## Report on a Publicly Notified Resource Consent Application

(Section 42A)

<b>Application Reference:</b>	RMA/2018/2029
<b>Applicant:</b>	Foodstuffs South Island Limited
<b>Site address:</b>	171 & 165 Main North Road; 7, 7A, & 7B Northcote Road
<b>Legal Description:</b>	Lot 1 DP 21207, Lot 1 DP 479583, Lot 1 DP 1440, Lot 7 DP 14400, Lot 9 DP 14400, Lot 2 DP 479583, Lot 1 DP 76152
<b>Proposal:</b>	Establish and operate a supermarket with associated self-service petrol station, ancillary offices, emergency coordination facility, car parking, roading realignment (addition of a signalised intersection along Main North Road), signage, earthworks, and modifications to the Lydia Street Drain (a network waterway)
<b>Zoning:</b>	Industrial General, Commercial Local, and Residential Suburban
<b>Overlays and map notations:</b>	Christchurch International Airport Protection Surfaces overlay Liquefaction Management Area Water Body Setback (Network Waterway) Flood Management Area Major Arterial Road (Northcote Road) Minor Arterial Road (Main North Road)

Figure 3. Landscape Plan showing pedestrian connections along Main North Road.

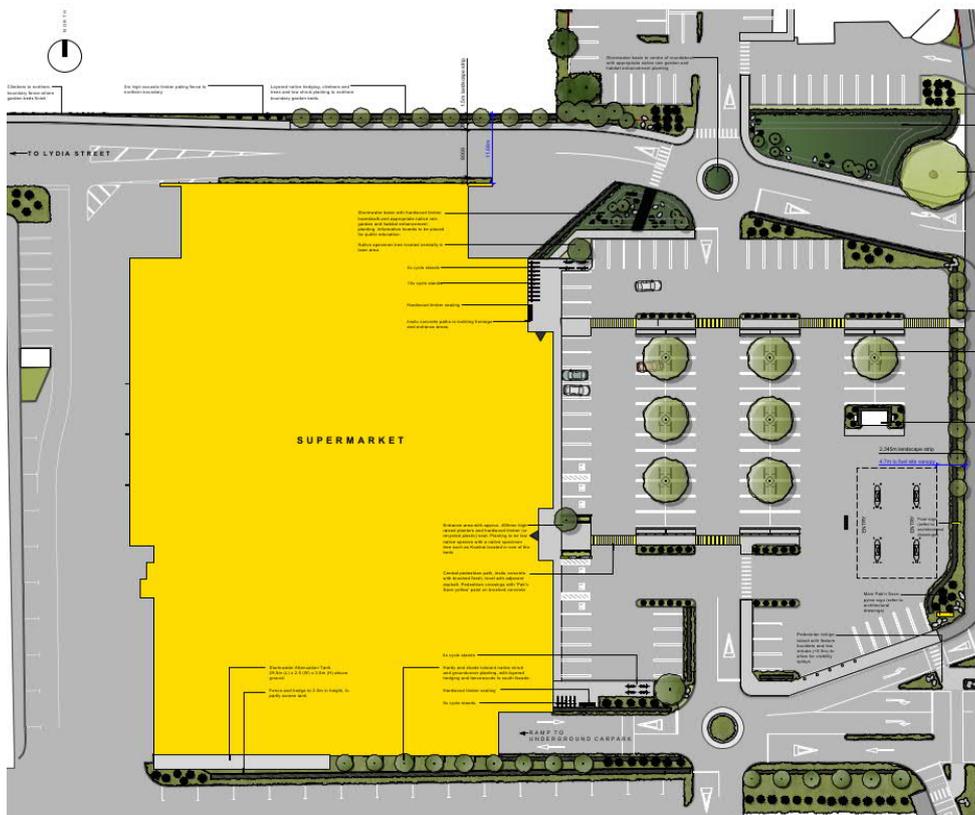
83. In my view, more concerning than the above is the quality of the main pedestrian connections to Main North Road and that to Lydia Street. In particular, the southern pedestrian access to Main North Road follows a circuitous route that will run next to the main vehicle access (see Figure 3). This access narrows to a width of 1.1m where it passes bollards used for the petrol station refuelling vehicle before turning north across the parking area, and then west to one of the main supermarket entrances. Mr Hattam considers that this access will feel indirect, and less safe and pleasant than the northern pedestrian walkway (discussed below). He considers that users may find use of this access an uncomfortable experience.

84. Ms Dray has recommended conditions of consent requiring additional landscaping adjacent to the southern pedestrian walkway east of the bollards (**Appendix E**). While this will increase the legibility of the connection, it will not mitigate concerns relating to amenity and, potentially, safety. It appears that this route has been largely mandated by the location of the service station at the front of the site, which means a straight access from Main North Road to the supermarket doorway, as provided for the northern access, cannot be provided here. As with the southern connection to the Foodstuffs Head Offices, I acknowledge that the Applicant has changed this access through the consenting process, with the original design causing traffic safety issues at the roundabout. However, where the lack of connection between the head offices and supermarket will be experienced primarily by those working at the site, the southern connection to Main North Road will be experienced by the general public. Furthermore, it will be one of the primary pedestrian accesses to the site. This raises greater concerns in my mind than the internal connection to the head offices building, and again points to issues with site layout.

**Figure 4.** Site plan showing revised location of gates and fencing at the rear of the supermarket (received from Mr Niko Young, 30/10/19).

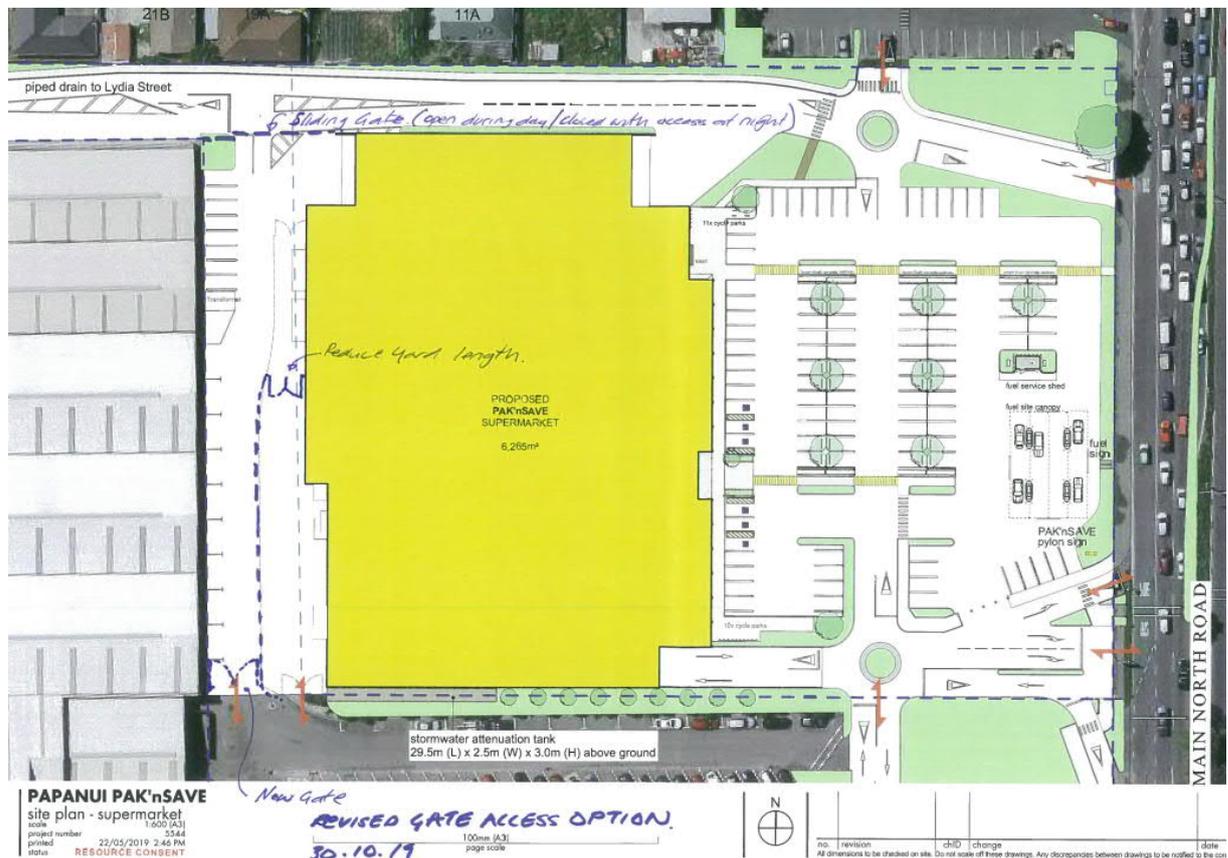
93. Ms Dray is of the opinion that the area to the rear of the supermarket remains a CPTED issue, despite the gating proposed during night-time hours by Mr Young. She has recommended that aspects of the design can be modified to create a safer environment. These include:

Figure 11: PM peak difference in flows, development model versus baseline, 2021

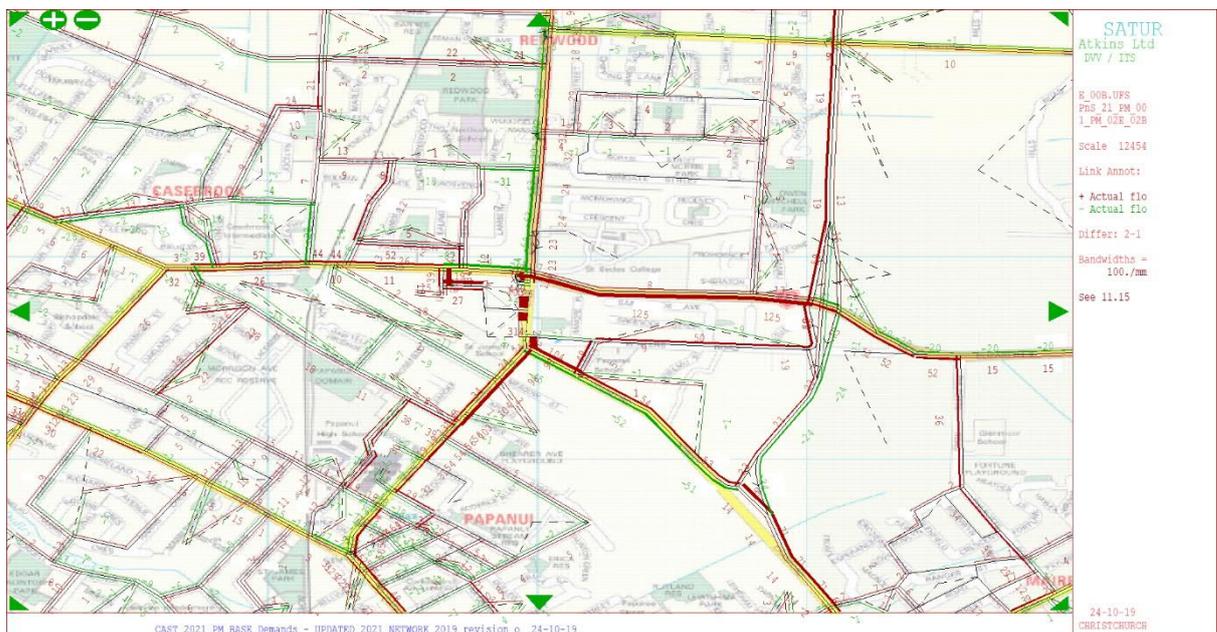
186. Figure 11 shows the increase of traffic, resulting from development. The forecast turning movements are available in the Appendices (Figure 20 -Figure 22). Changes include:

- a. The Main North Road northbound approach total (south of QEII Dr) remains largely unchanged, and the demand for capacity remains critically high at around 98%. The main difference for the south approach is that more traffic is modelled to turn right and fewer vehicles continue northbound, than in the baseline. (See Figure 23, p84). Henceforth there is no real option to add further traffic to this approach, without relying on rerouting, or demand that exceeds capacity.

Figure 19: Access referencing, lifted from ITA p22

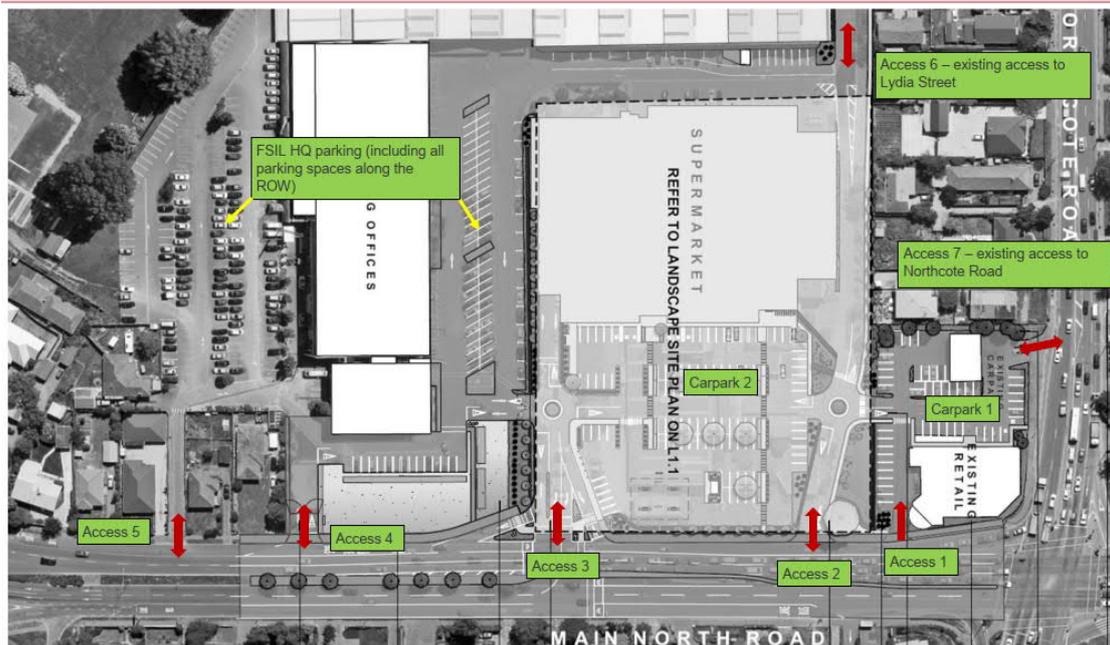
270. In my opinion, there is no need for both Access 1 and Access 2 (see Figure 19), that could not be provided by a single access point between the two. Although Figure 2 does serve a right of way, it is possible for access 1 and access 2 to become a single point of access (with an amendment to the ROW registered with LINZ).

271. Furthermore, there are concerns that demand for Access 7 (see Figure 19, above) from Northcote Road could have effects on the capacity of Northcote Road and the QEII Drive / Northcote Road / Main North Road intersection. Again,

**Figure 2-1: XY Scatter Plot (Data Points)**

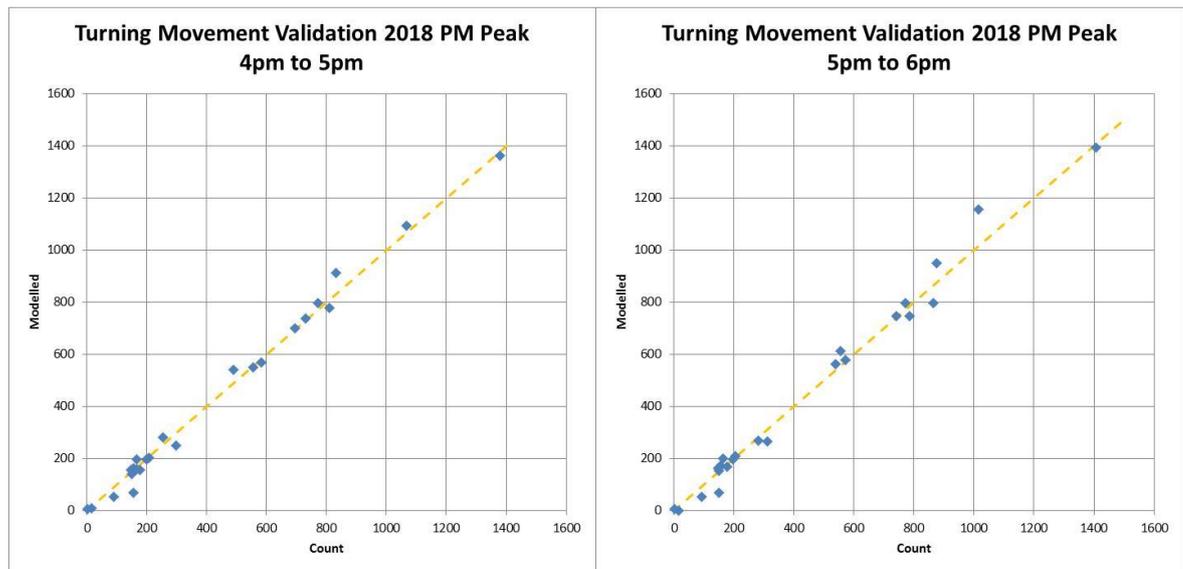
2.7.6 From these results, I conclude the following
